**RE: SECTION 4.55(1A) MODIFICATION APPLICATION TO DA/1613/2015 FOR BOWDEN
BRAE VILLAGE, NORMANHURST**

This statement has been prepared on behalf of Uniting by City Plan Strategy and Development Pty Ltd to accompany an application under Section 4.55(1A) of the Environmental Planning and Assessment Act 1979 (the Act).

Figure 3 GFA comparison plan (Building C) (Source: PTW Architects)

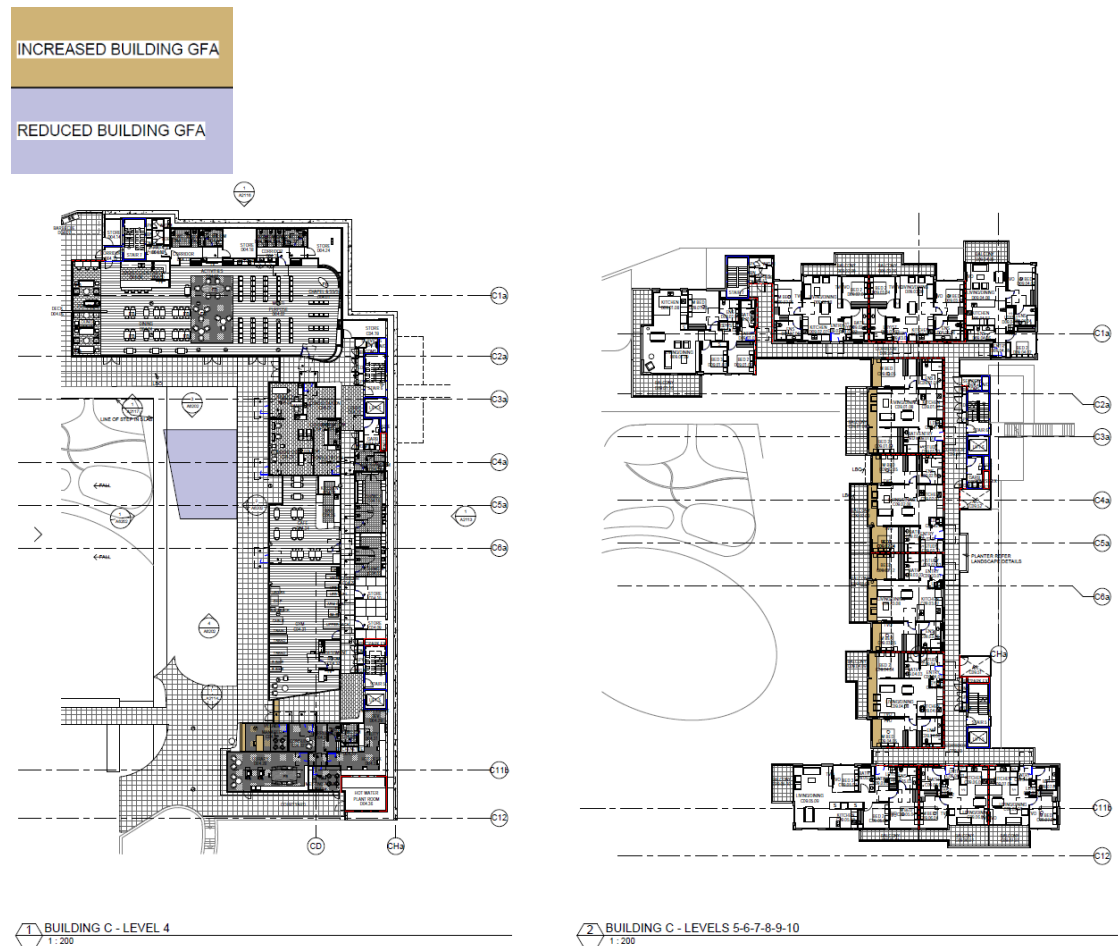
- Consolidation of approved construction stages 2 and 3 into a single construction stage;
- Removal of the five (5) approved respite care units (6 beds) in Building D and replacement with three (3) ILUs;
- Minor extension of the building envelope at the upper levels of Building C to give larger living areas which we understand will better meet the emerging market expectations in this sector;
- Minor internal changes to Buildings B and C, primarily with a view to changing some of the two (2) bedroom ILUs to two (2) bed + study ILUs;
- Relocation of the approved free-standing pavilion café (internally within the site) into the main envelope of Building C at Level 4. This modification also results in a minor reduction in the areas for the approved gym and hair salon at the same level to accommodate the relocated café;

The plan extracts below, prepared by PTW Architects, provide a visual representation of the reduced versus increased building footprint/GFA, which only applies to approved Buildings B and C.

Figure 4 GFA comparison plan (Building B) (Source: PTW Architects)

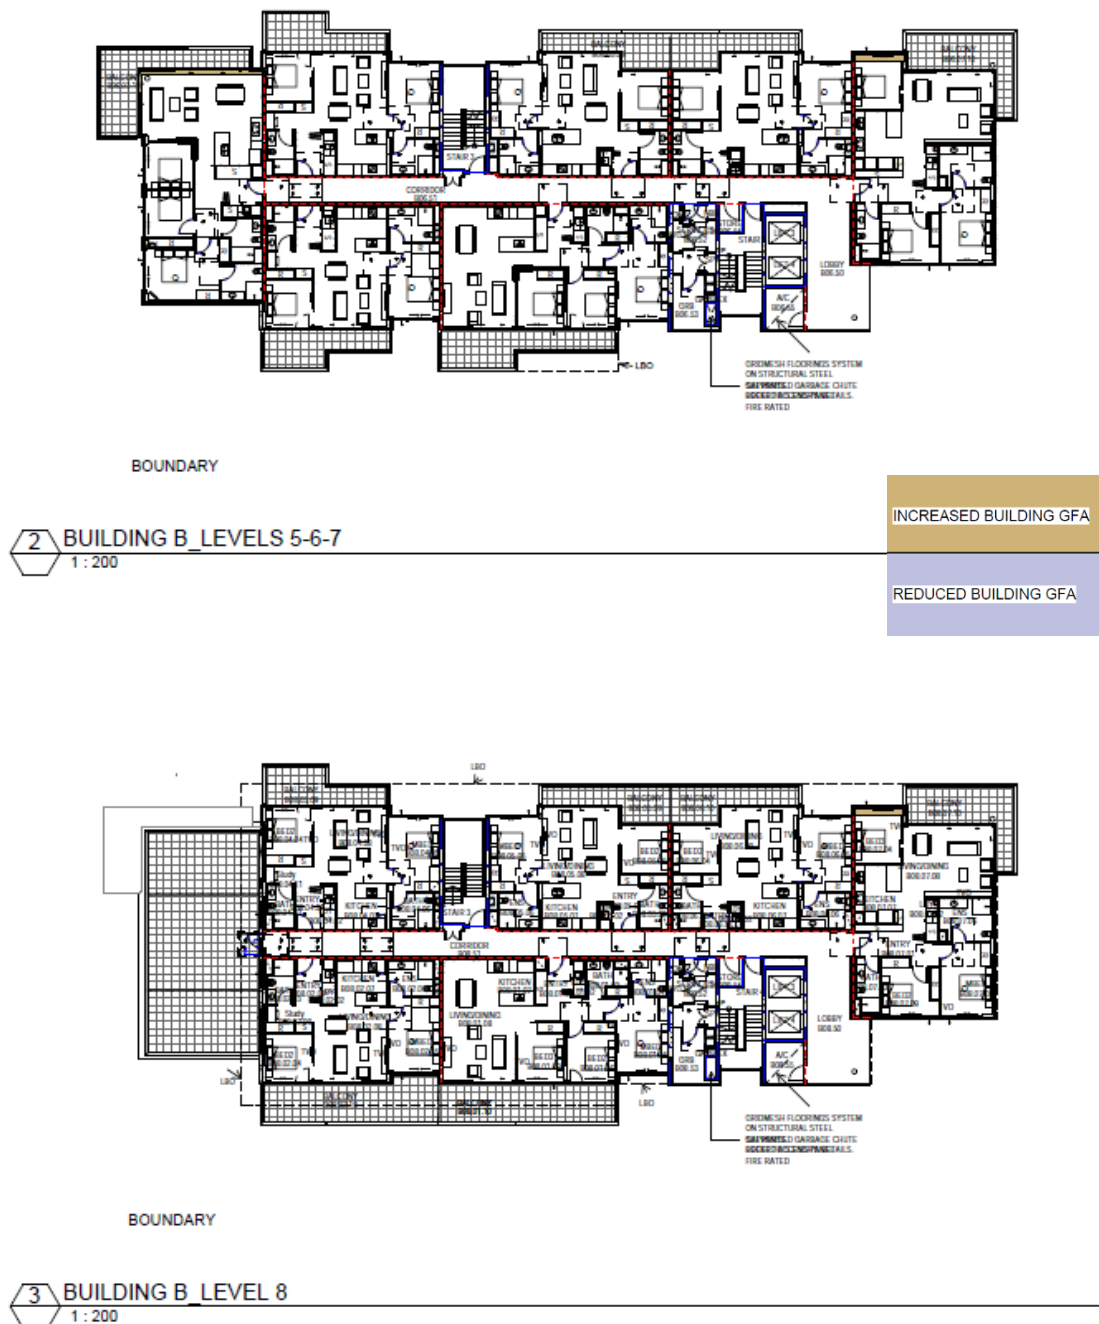
- Minor extension of the glazed corner walls within Building B at the upper levels to give more generously scaled living rooms;
- Minor increase in the extent of the basement to Building C (Level 3) to accommodate three (3) additional car spaces; and
- Minor extension of the building envelope at the entry of Building C to accommodate an additional consulting room near the entry.

Figure 5 Massing Axonometric (Source: PTW Architects)

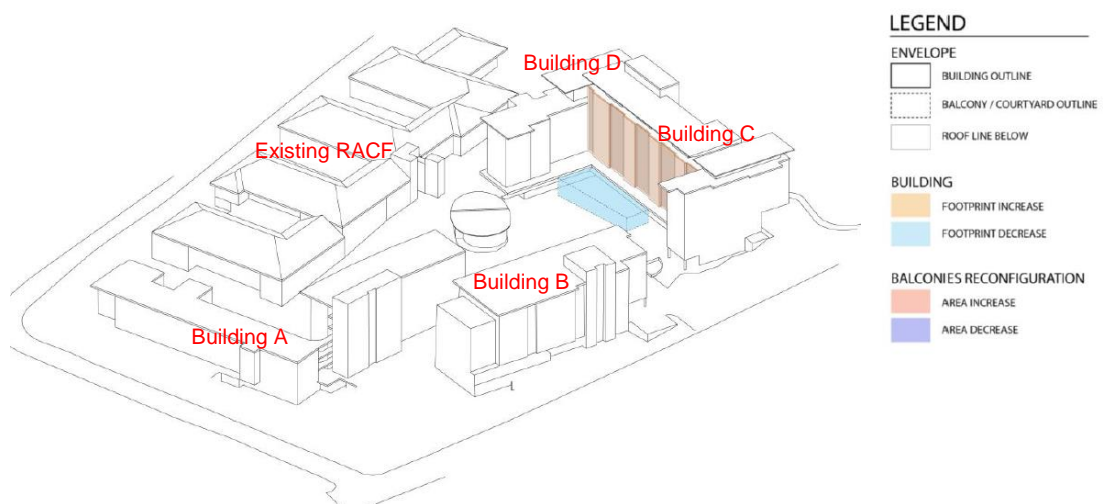
The height, bulk and scale of the approved development will remain largely unchanged. The primary change to the building envelope relates to the north-western façade of Building C (shaded brown in the figure below) where the building envelope is marginally increasing to enhance internal amenity of the ILUs within this elevation/building. The free-standing café will be removed (shaded in blue) and relocated internally within Building C. The figure on the page over, prepared by PTW Architects, provides a visual representation of the primary areas of reduced and increased built form.

The proposed increase of the building envelope of Building C (brown shading above) is minor and acceptable for the following reasons:

- This part of the building is well separated from other existing and approved buildings on-site and the minor increase in built form will not change the relationship, nor result in any impact on, adjoining (approved) Building D;

- This part of the building is well setback from the site's respective boundaries and as can be seen in the figure above, would generally not be visible from surrounding streets (only a distant view of the upper levels may be visible);

- In a quantitative sense, the increase in GFA associated with this modification to the building envelope is partly offset by the removal of the free-standing café (in blue in the figure above);
